[Docket No. FAA-2020-0442; Project Identifier AD-2020-00260-E; Amendment 39-21640; AD 2021-14-13]

Airworthiness Directives; Pratt & Whitney Turbofan Engines

ACTION: Final rule.

Figure 1 to Paragraph (g)(1)(iii) – Crack Inspection Critical Areas

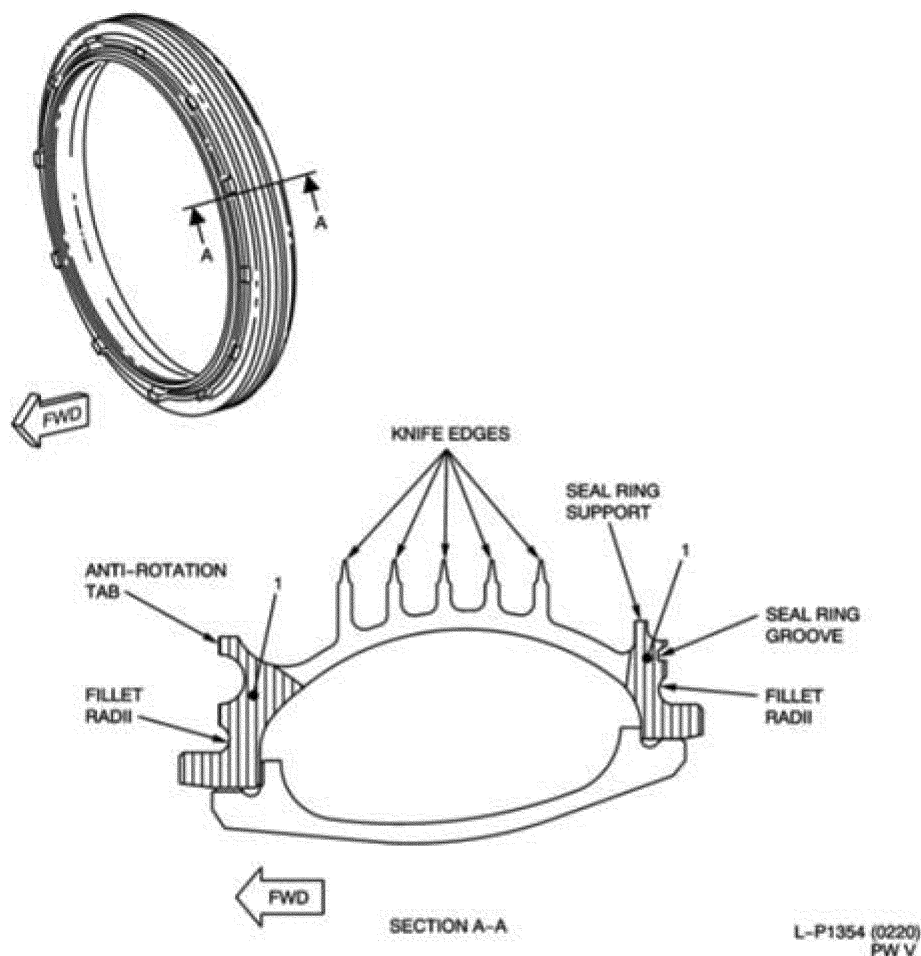
Delta commented that individual part serviceability should not depend on the inspection results of other parts. Delta also commented that if inspections are not possible which would allow the mating HPT 1st-stage disk or the HPT 2nd-stage hub to be deemed serviceable, independent from inspection status of the HPT 2nd-stage air seal assembly, then the manufacturer should revise the engine manuals to clarify that the mating HPT 1st-stage disk or HPT 2nd-stage hub cannot be made serviceable unless an inspection of the HPT 2nd-stage air seal assembly indicates it is free of cracks. Delta stated that this would remove the possibility that the mating HPT 1st-stage disk or HPT 2nd-stage hub would be made serviceable and then installed in an engine before the HPT 2nd-stage air seal assembly is inspected.

Delta and MTU requested that the FAA clarify the location of the forward and aft edges of the HPT 2nd-stage air seal assembly. Delta asked if the forward edge is the barrel section forward of the #1 knife-edge or any part that extends beyond the barrel section.

Delta and FedEx requested that the FAA clarify the definition of "through-crack." Delta asked if a "through-crack" is a crack going through the axial direction or radial direction of the HPT 2nd-stage air seal assembly. Delta referenced Figure 5 of NDIP-1217 that appears to show a through-crack in the axial direction. Delta inferred from paragraph (i)(4) of the NPRM that a through-crack is in the radial direction. Delta requested a diagram to help illustrate what constitutes a through-crack.

The FAA did not revise this AD in response to this comment. A crack, as identified in the shaded regions of Figure 1 to paragraph (g)(1)(iii) of this AD (Figure 1), which extends towards the knife-edge region of the HPT 2nd-stage air seal assembly, impacts the serviceability of the mating HPT 1st-stage disk and the HPT 2nd-stage hub. A crack identified in the shaded region of Figure 1 of this AD of the HPT 2nd-stage air seal assembly results in the

If a crack is found as identified in the shaded region of Figure 1 to paragraph (g)(1)(iii) of this AD (Figure 1) that

extends toward the knife-edge region of the HPT 2nd-stage air seal assembly, this AD requires replacement of the HPT 2nd-stage air seal assembly, mating HPT 1st-stage disk, and HPT 2nd-stage hub.

The FAA removed references to "forward edge" and "aft edge" of the HPT 2nd-stage air seal assembly from this AD. In their place, the FAA added Figure 1 to paragraph (g)(1)(iii) of this AD to specify the locations of the HPT 2nd-stage air seal assembly that require inspection for cracks.

The FAA agrees that it is difficult to differentiate between a surface crack and through-crack; therefore, the FAA removed references to “through-crack” from this AD. The FAA notes that any crack, in any direction, found in the HPT 2nd-stage air seal assembly, requires removal of the HPT 2nd-stage air seal assembly from service. As stated in an earlier response, the FAA added Figure 1 to show the locations of the HPT 2nd-stage air seal assembly that require inspection for cracks. However, the FAA is not providing dimensions that bind the areas. If the inspections of the HPT 2nd-stage air seal assembly reveal a crack in the shaded regions of Figure 1, which extends towards the knife-edge region, the HPT 2nd-stage air seal assembly must be removed from service.

(iii) During the visual inspection or FPI required by paragraph (g)(1)(i) of this AD, if a crack is found in the shaded regions of the HPT 2nd-stage air seal assembly identified in Figure 1 to paragraph (g)(1)(iii) of this AD (Figure 1), which extends towards the knife-
